Sacramento Intermodal Transportation Facility

Tier 1 and Tier 2 Environmental Assessment with Finding of No Significant Impact and Section 4(f) Evaluation

August 2009

Figure 1-6
Phase 3 - Don't Move the Depot Option

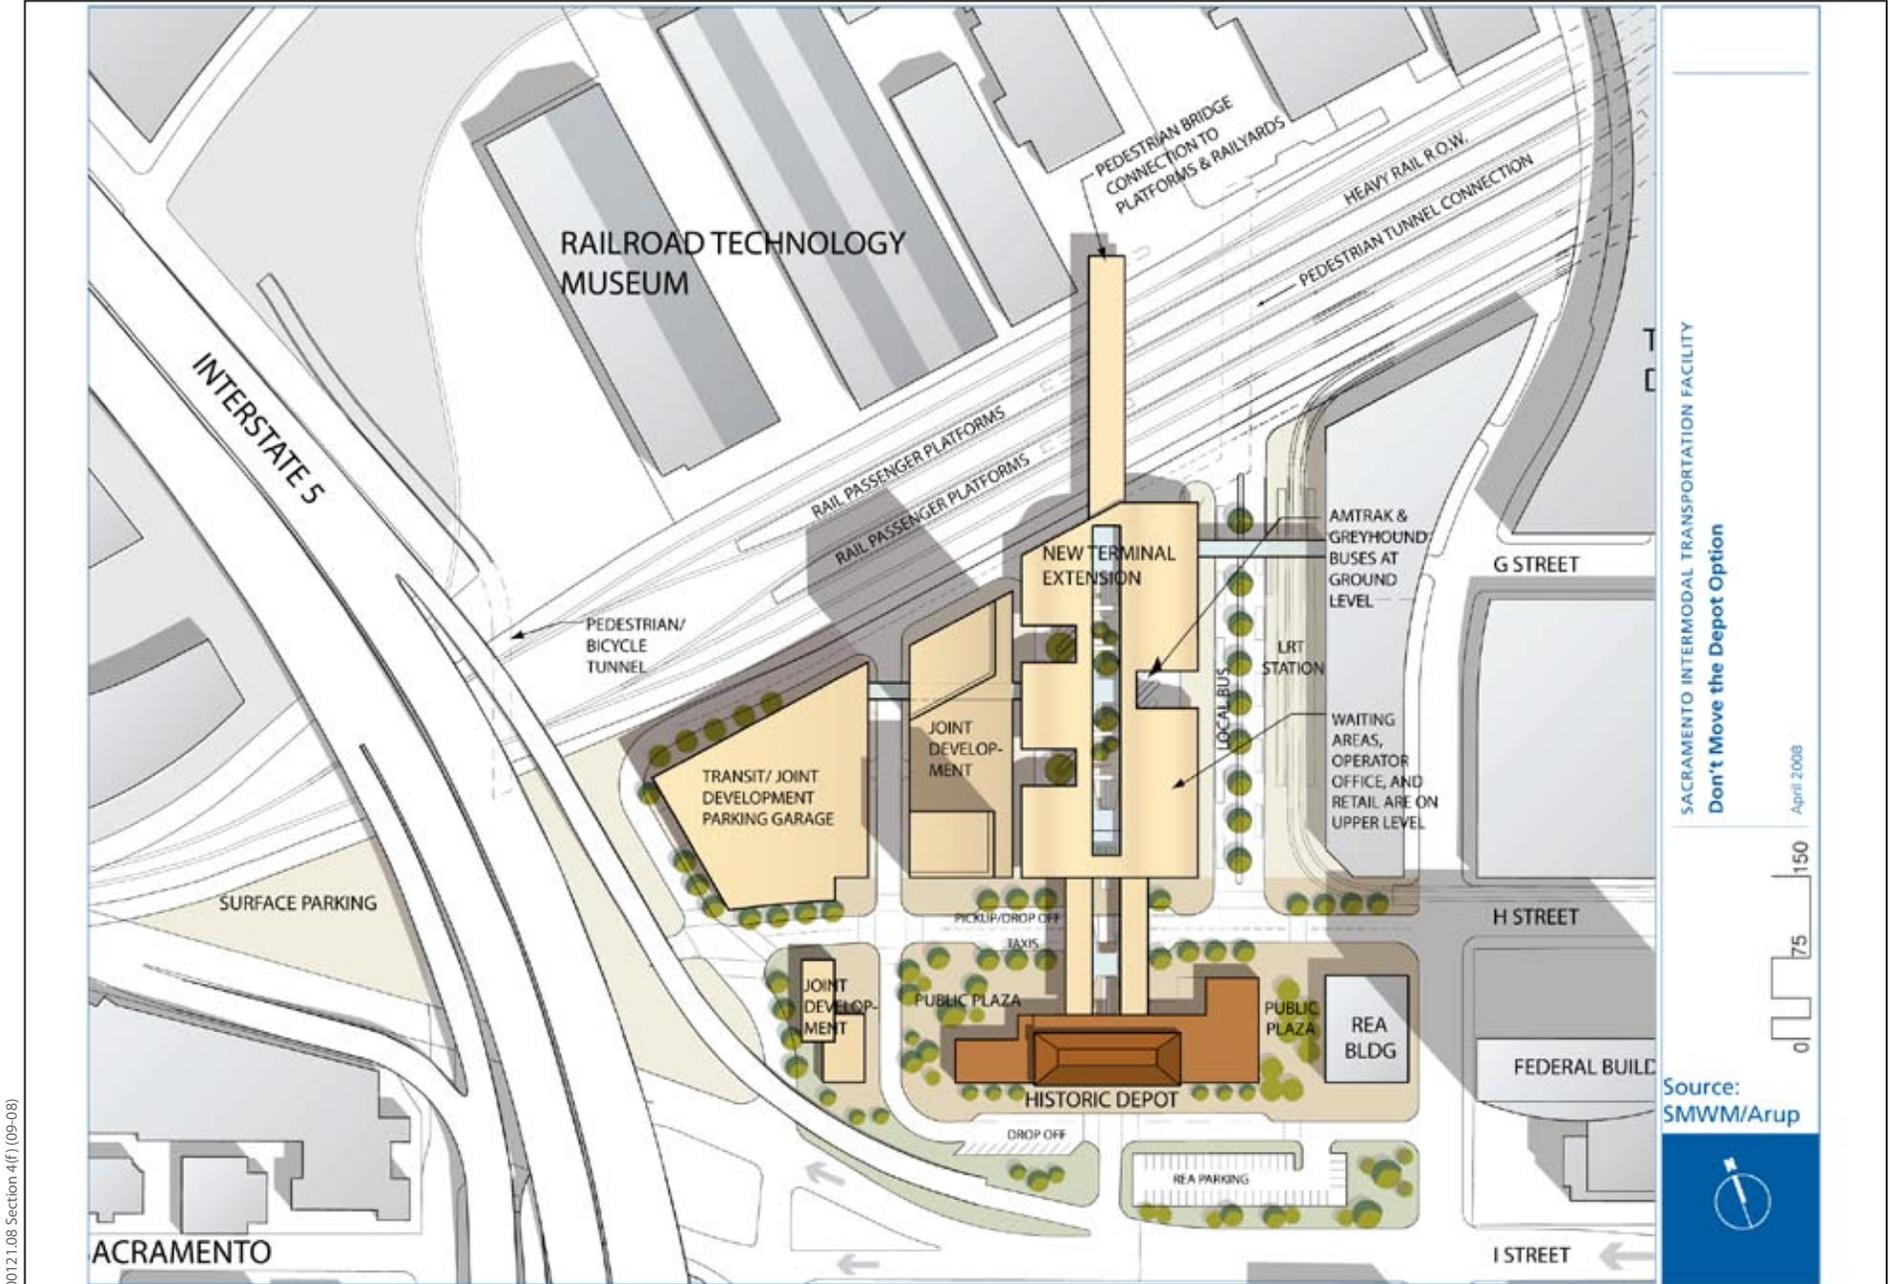
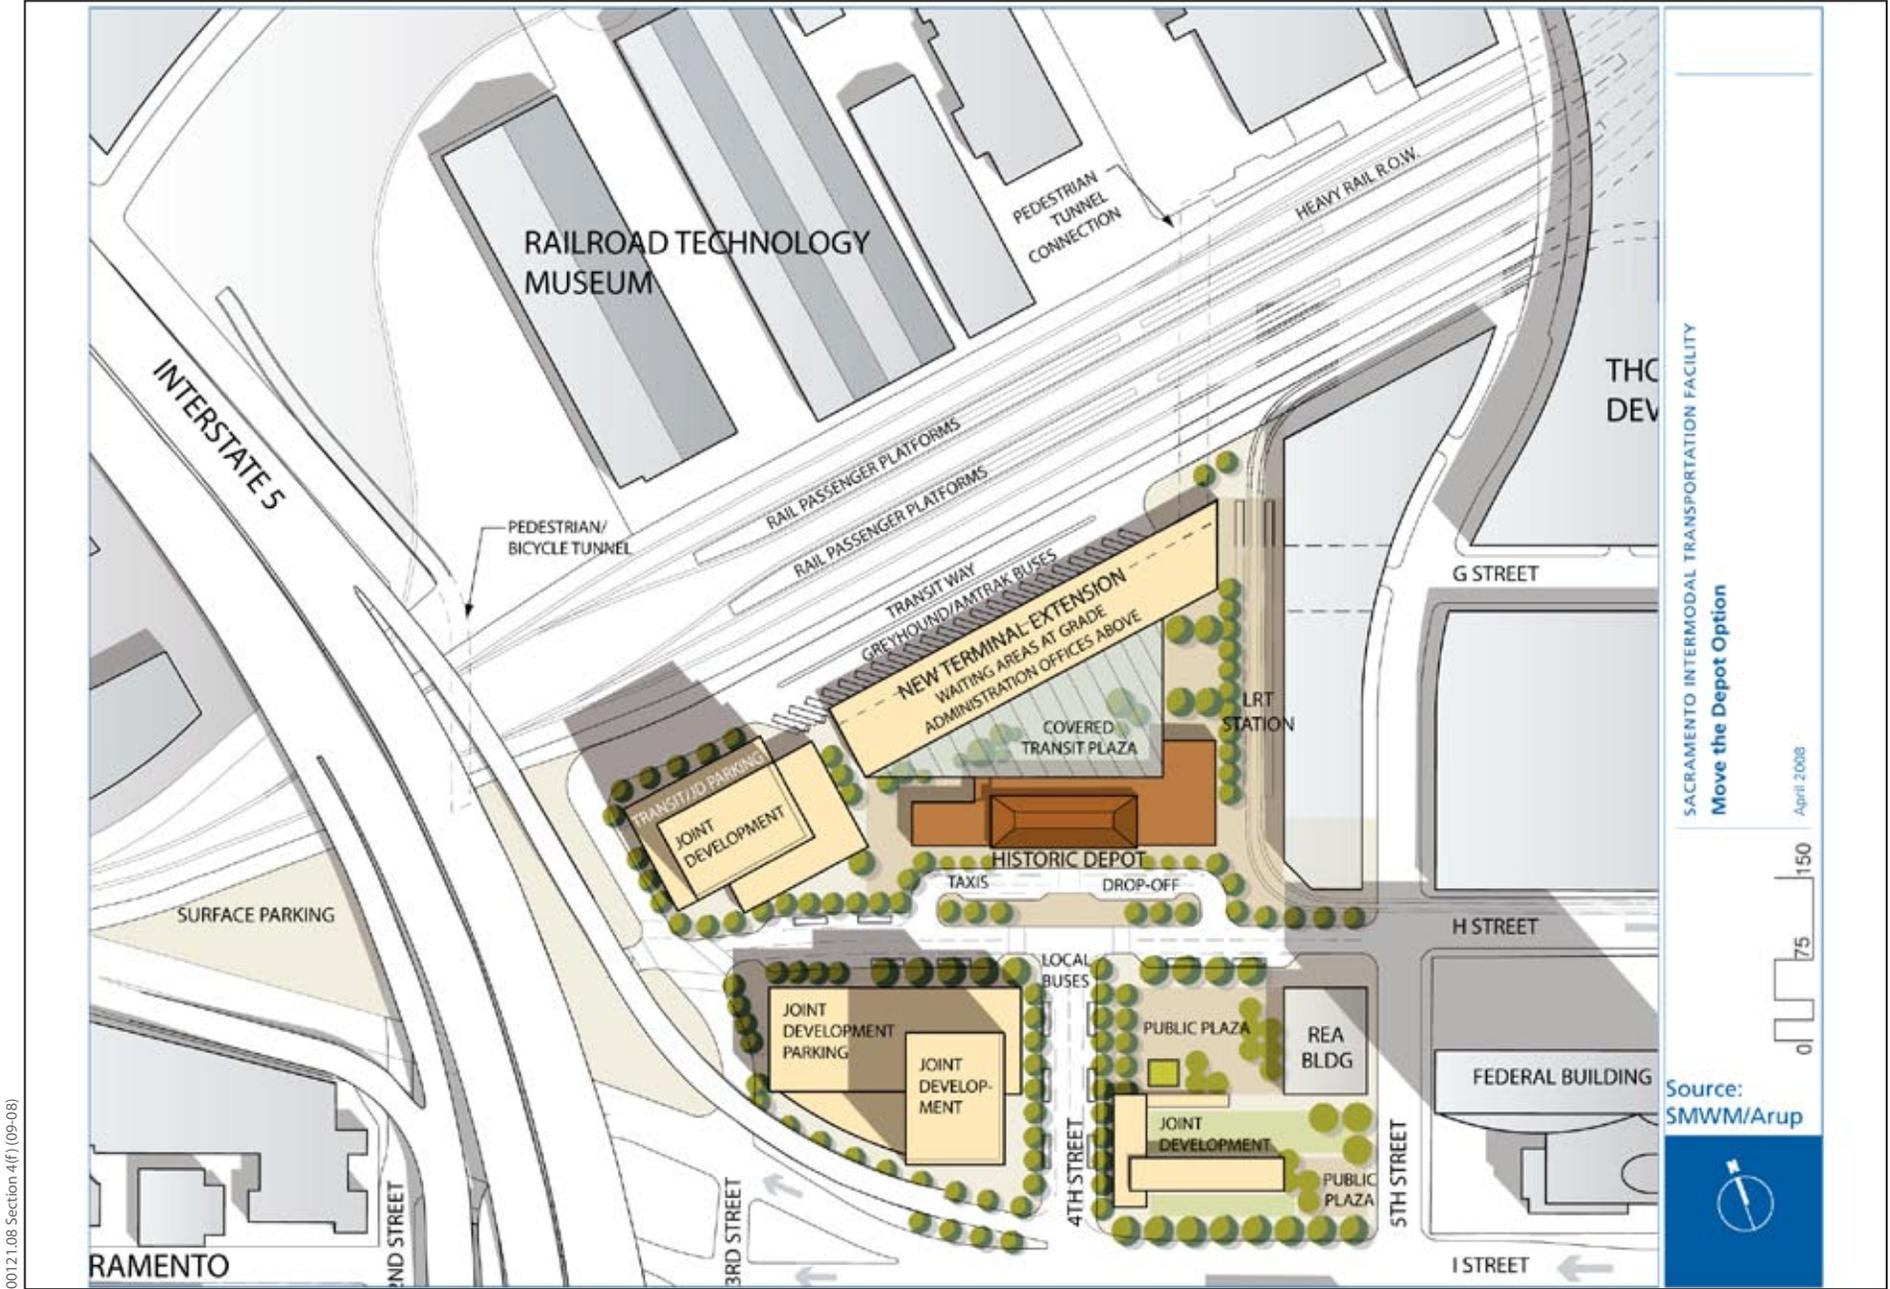
- The District notes that there is potential for an additional North-South Roadway Connection between Third Street and Bercut Street to the west side of the project site. Figures 1-6 and 1-7, which depict both the *Move the Depot* and the *Don't move the Depot* project alternatives, show that both options include an internal roadway connection along the project's Western boundary linking parking and passenger drop-off sites to the intersection of I and Third Streets. It is conceivable that this internal roadway could be expanded to connect Third street to Bercut street. The District recommends that the City project consider this potential future connection in the project's design and leave sufficient right of way to allow its potential development in the future. This connection would 3-7
